## Melissa Parsons Practical Task 1 2nd Occasion

**Project: RC5-523 70 The Strand (Anelay)**  
70 The Strand  
Townsville, Queensland 4810  
P: 0747713077

### RFI #130: Commercial | Plumbing Fixtures Final

Drawing No :  
Project Stage Discipline / Drawing No.  
**1910 / CD / A - C-610**

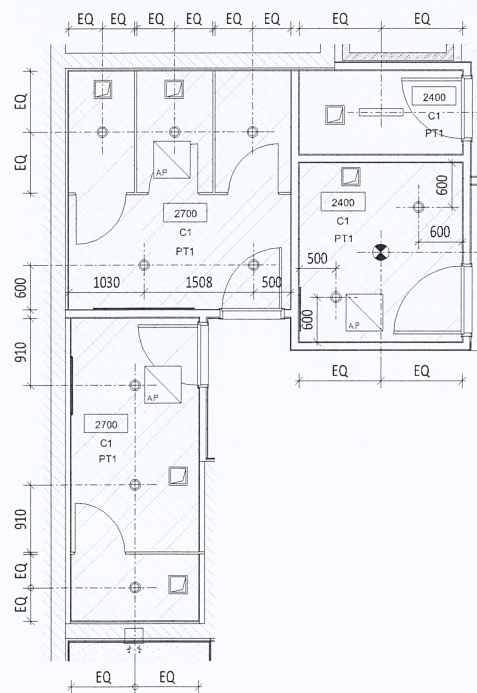
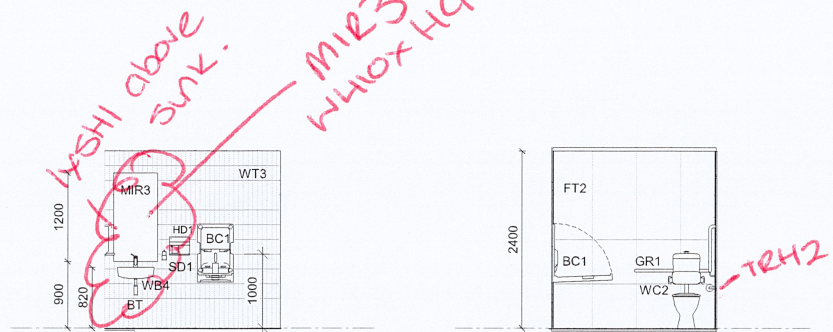
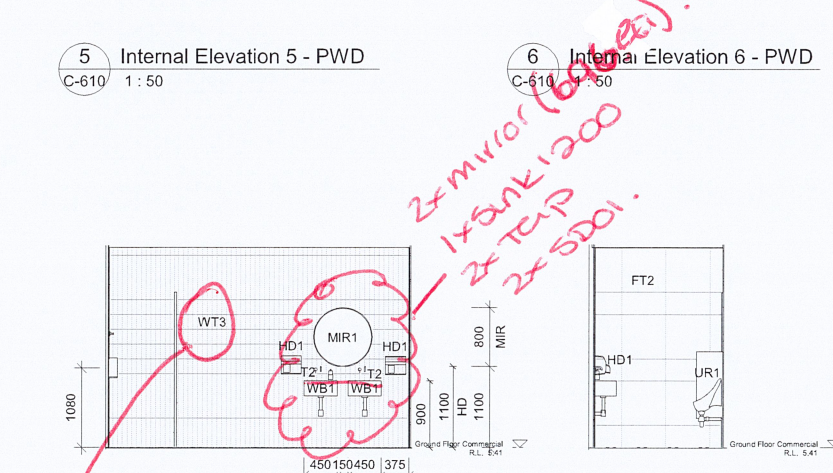
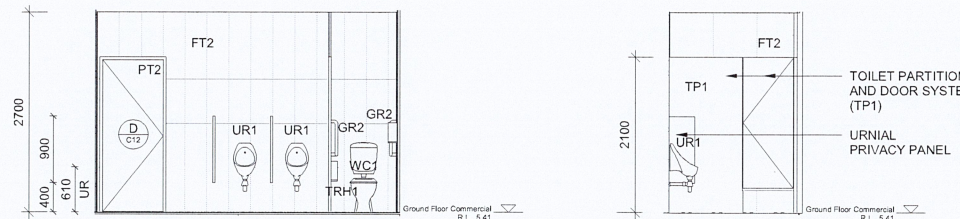
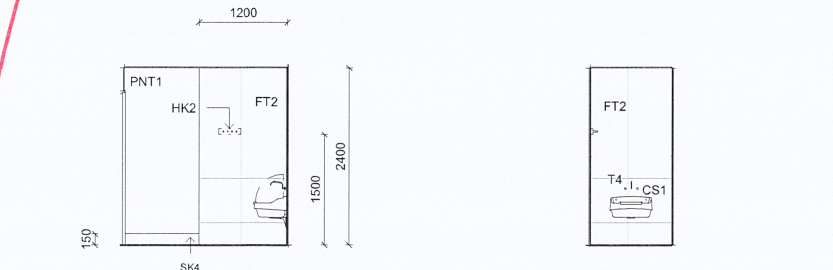
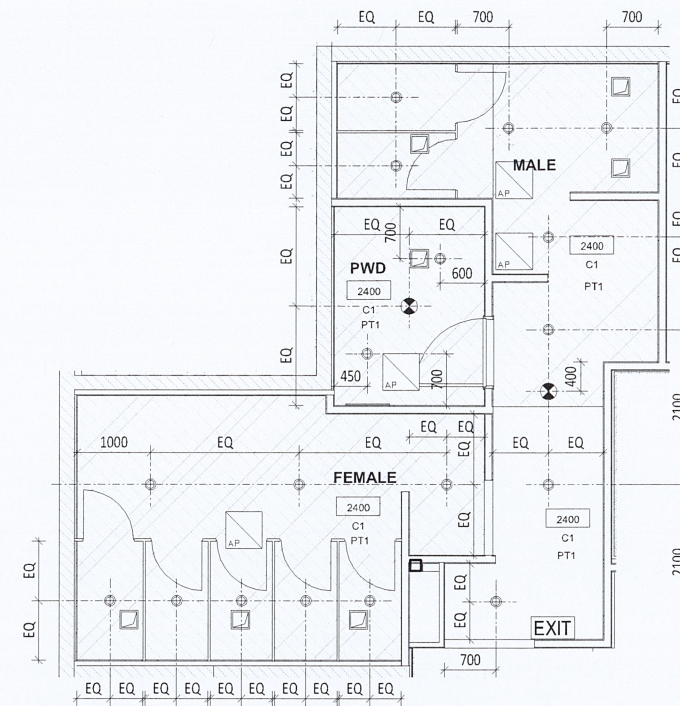
Good morning Chris & Tim  
Please find attached the final Plumbing Fixtures presentation from HNC. Please amend your schedule CAA-C-SCH-120 accordingly with the final changes  
I have also marked up the floor plans for GF & FF with the changes to be made, please note that GF Female, need to move HD from the corner to the open door of the Ambulant toilet please due to the change of basins  
Any questions please give us a call to discuss, amend and send back ASAP  
thanks  
Melissa

| <b>Official Response</b> | <p><b>Response from Chris Amerio CA Architects on Thursday, 17 Jun, 2021 at 10:28 AM AEST</b></p> <p>Hi Melissa,<br/>CA will review the revised fixtures/finishes &amp; update drawings accordingly, this will be captured in our next drawing issue. the next drawing issue date is TBC as we work through all the current design/client/buyer changes.</p>                                                                                                                                                                                                                                                                                                                                                                                                                                                                                                                                                                                                                                          |
